ADDENDUM DATE: December 14, 2023

ADDENDUM NO. 4

Cobblestone Manor
1050 Lamplighter Drive
Grove City, Ohio 43123

Addendum No. 4 to the Drawings and Project Manual, dated June 8, 2023, Cobblestone Manor as prepared by Moody Nolan, Inc., 300 Spruce St. Suite 300, Columbus, OH 43215.

DRAWING TITLE:
ENLARGED PLANS - ELECTRICAL

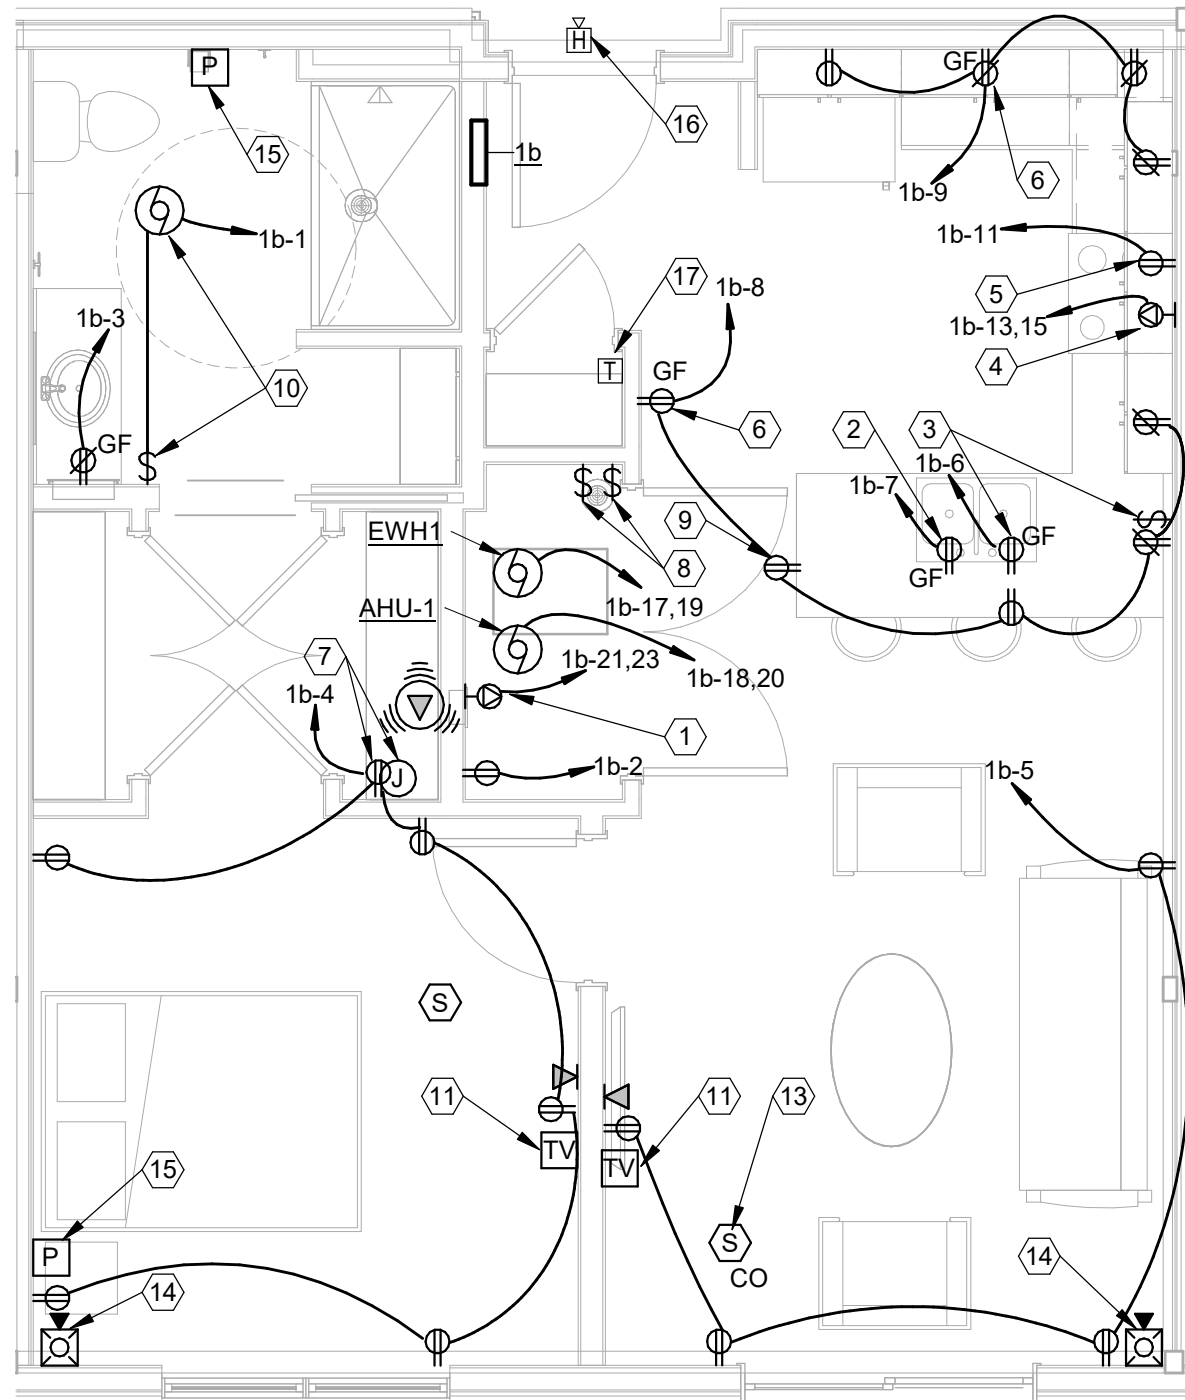
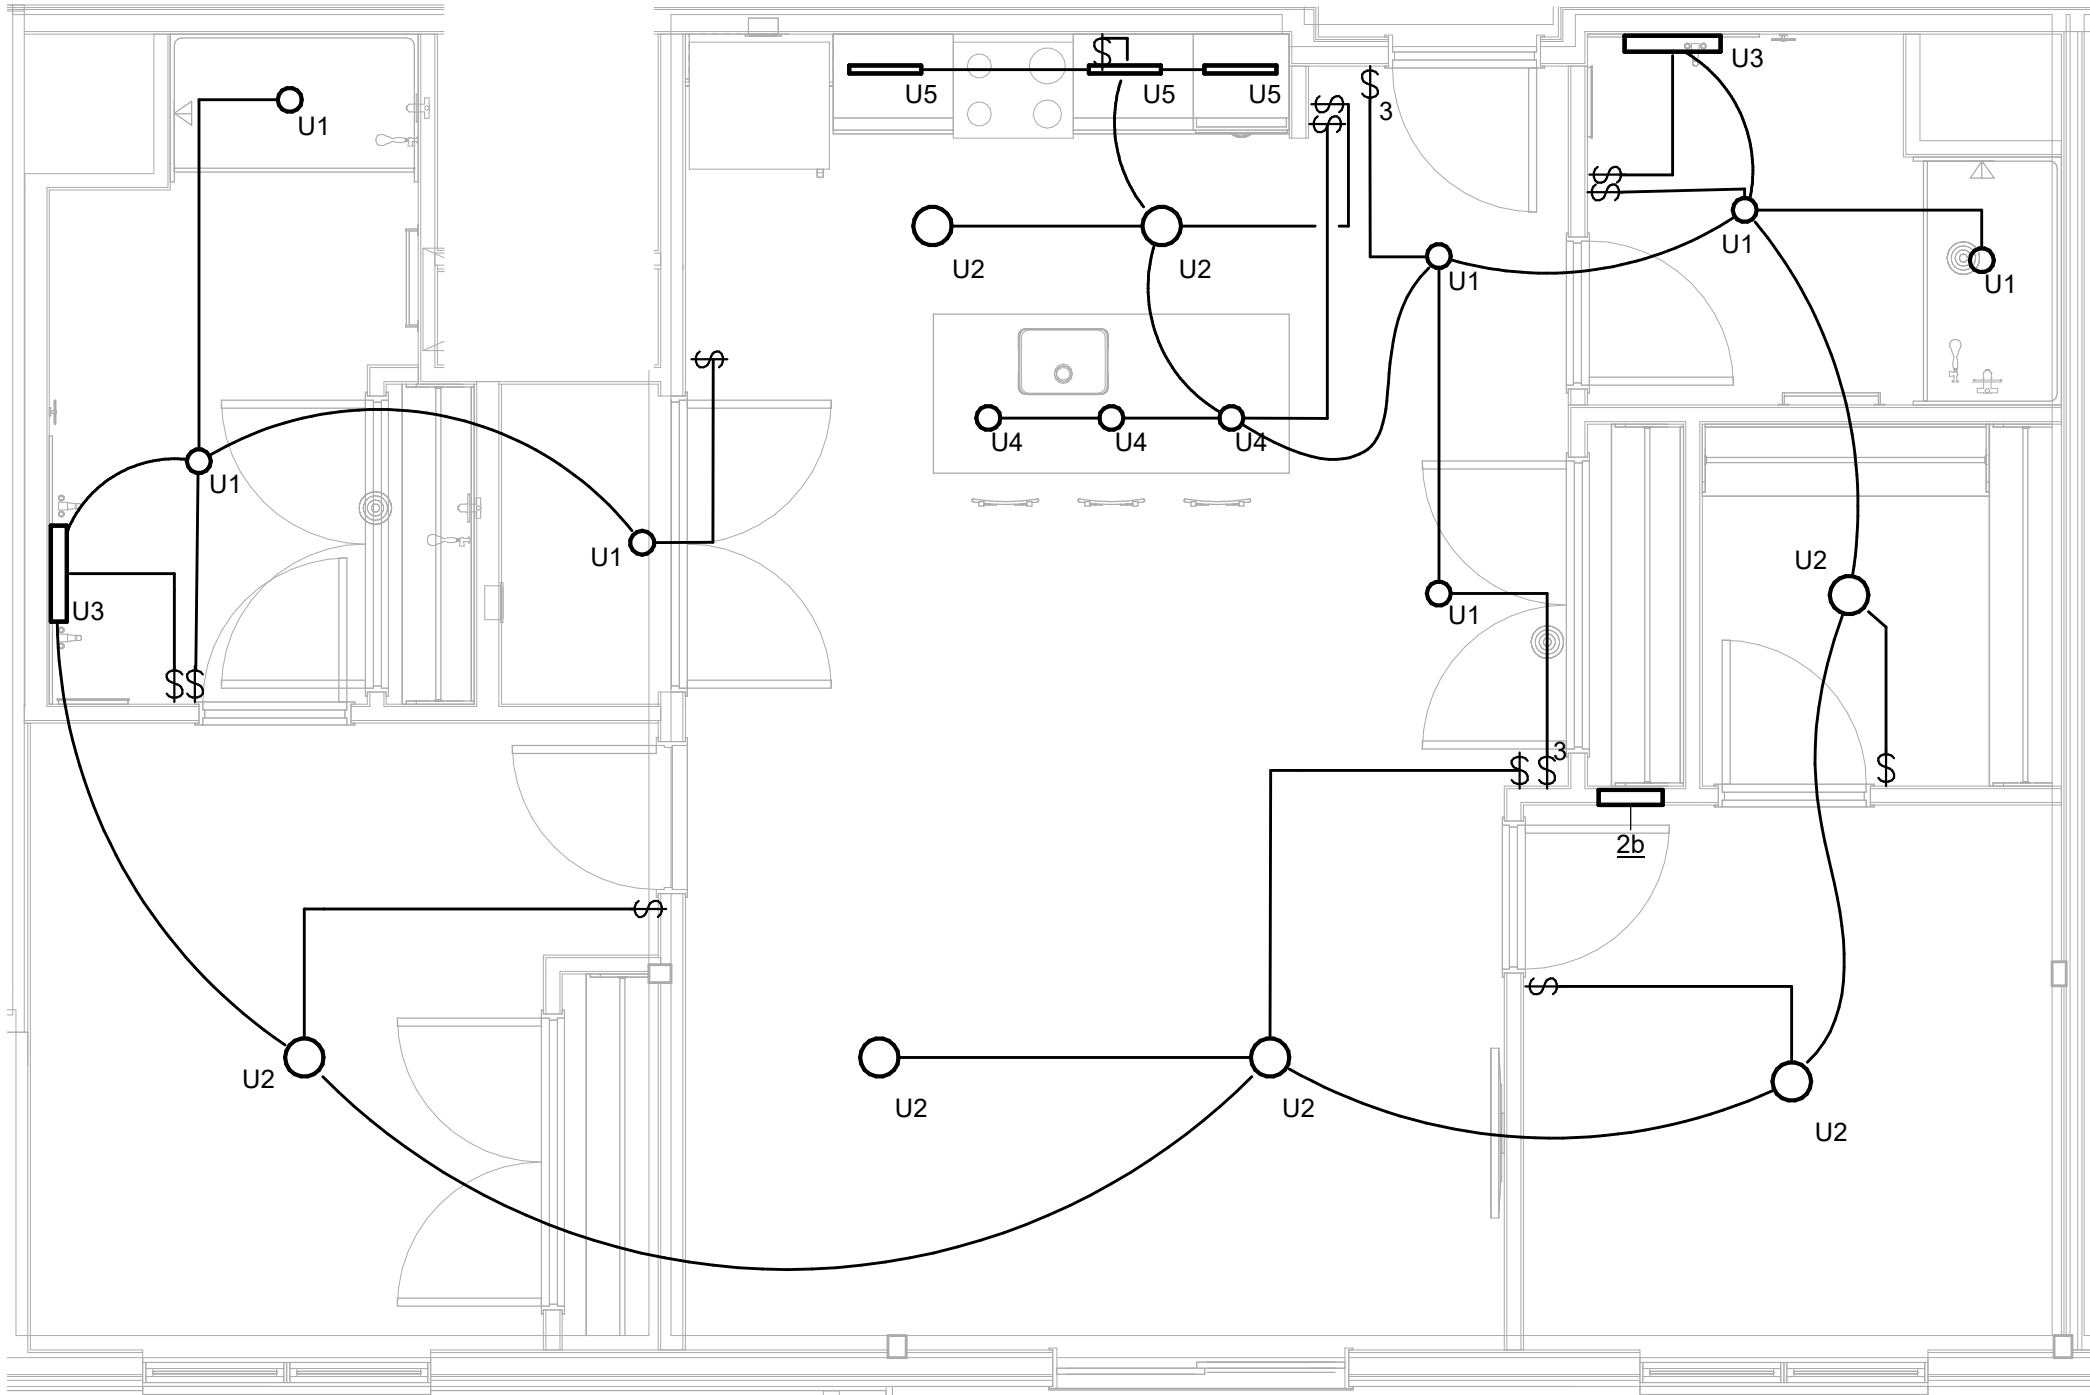
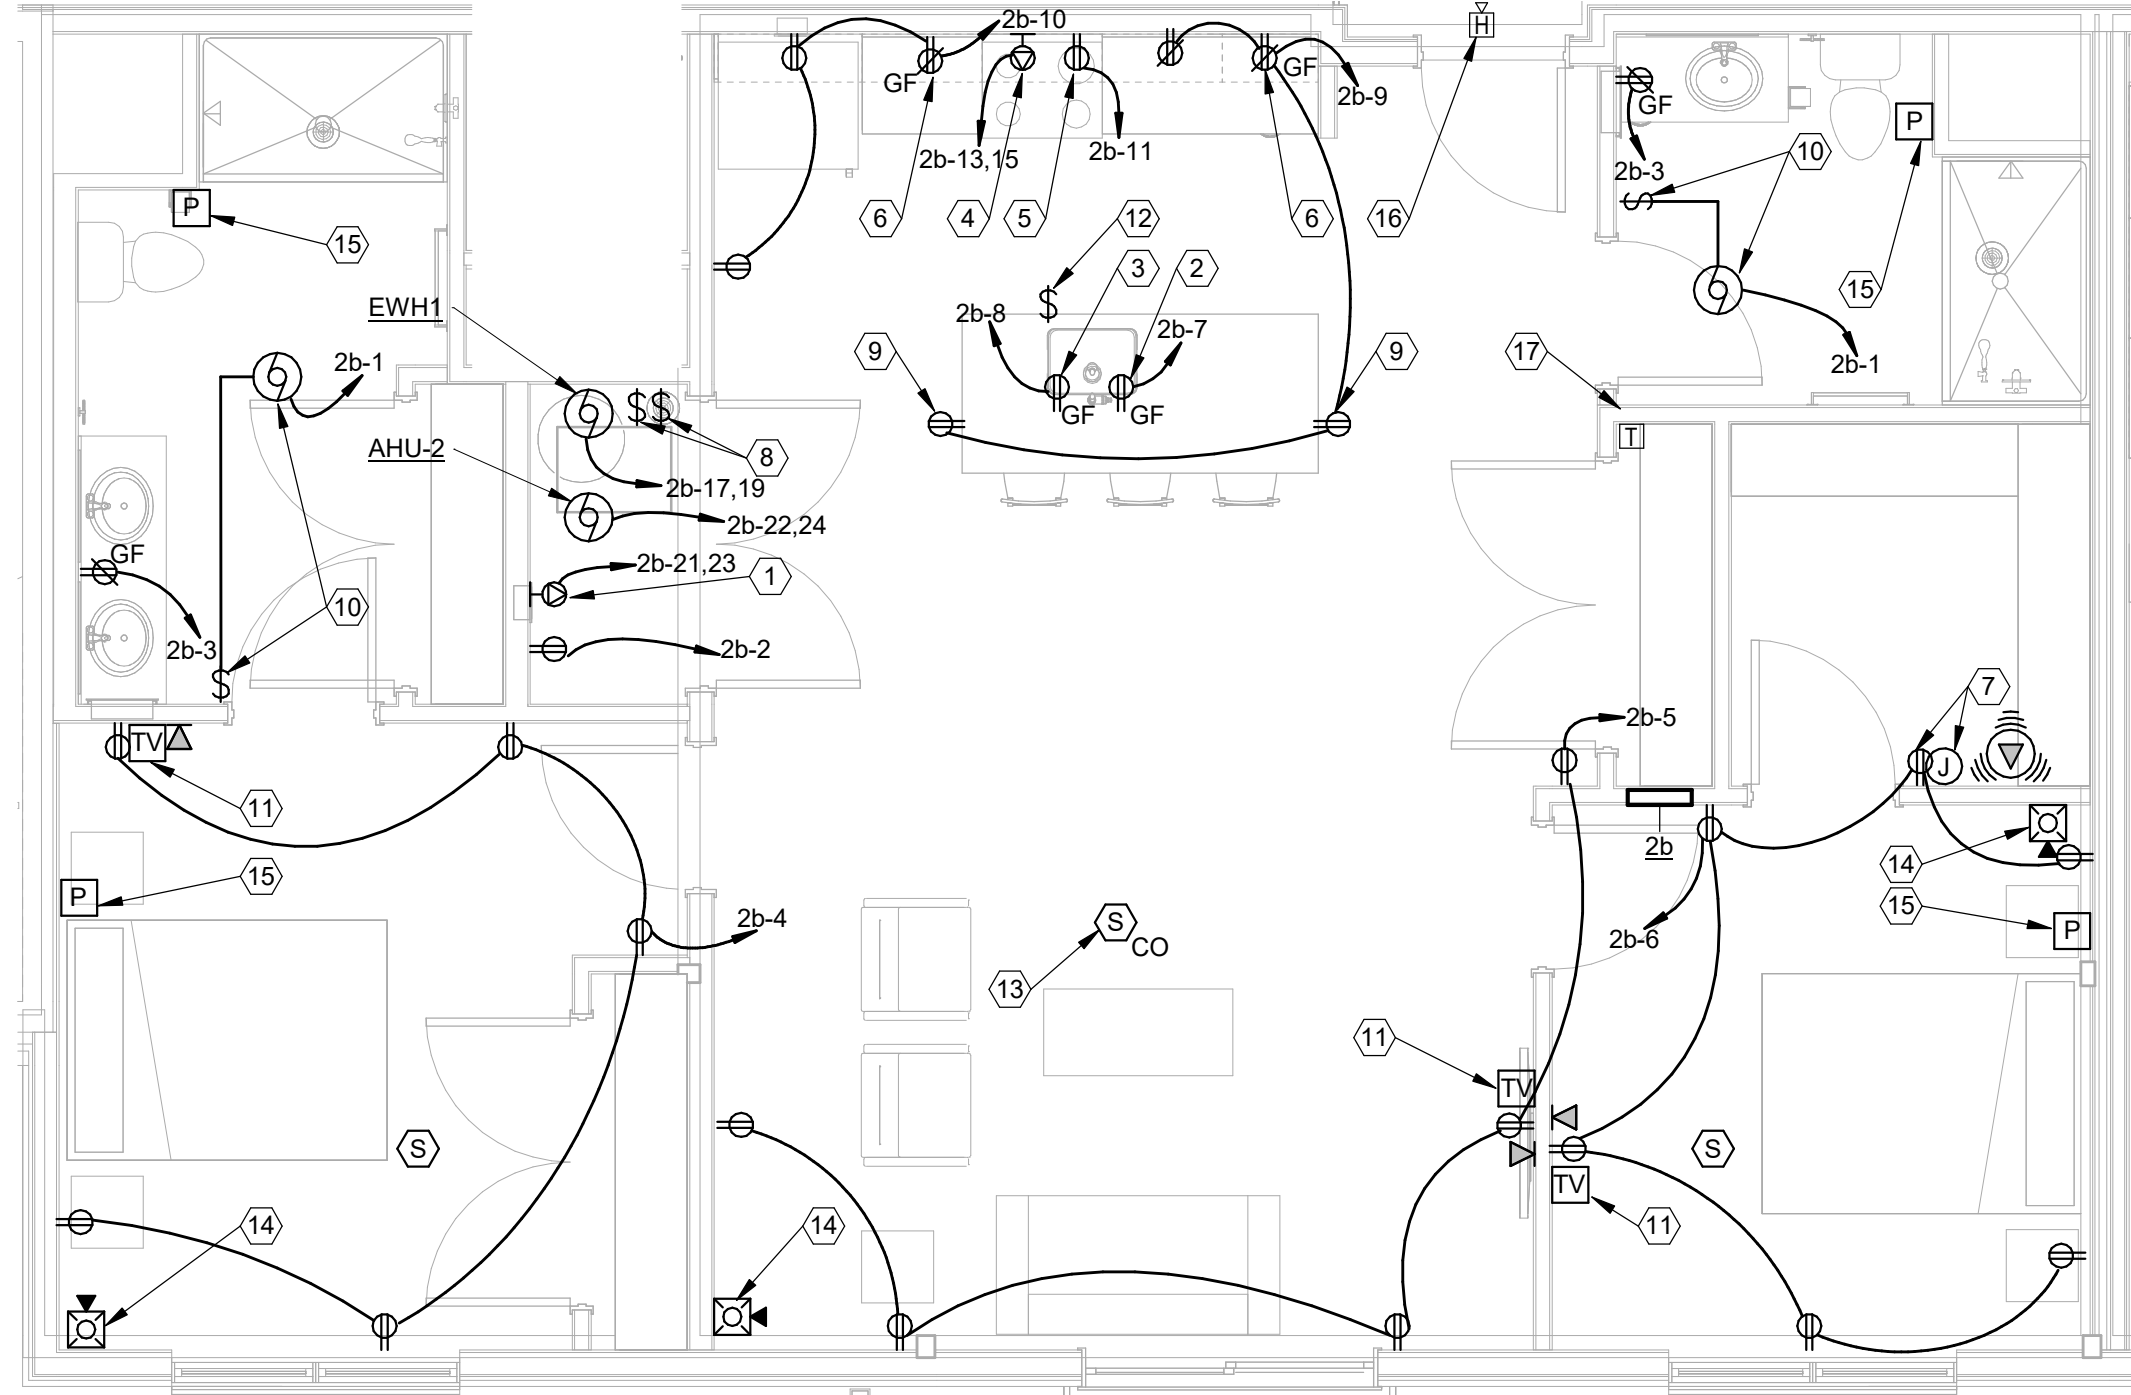
d. E401 – ENLARGED PLANS – ELECTRICAL

1. **DELETE** general notes M and O.
2. **ADD** RG6 and CAT6 cables from each residential unit structured media cabinet back to local demark, keynote 7.
3. **REVISE** General Note P to read as follows:
 - a. RESIDENTIAL UNIT SMOKE DETECTORS SHALL BE SYSTEM TYPE AND SHALL BE INTERCONNECTED IN SUCH A MANNER THAT ACTIVATION OF ONE DETECTOR WILL ACTIVATE AUDIBLE/VISUAL ALARMS WITHIN THE INDIVIDUAL UNIT.
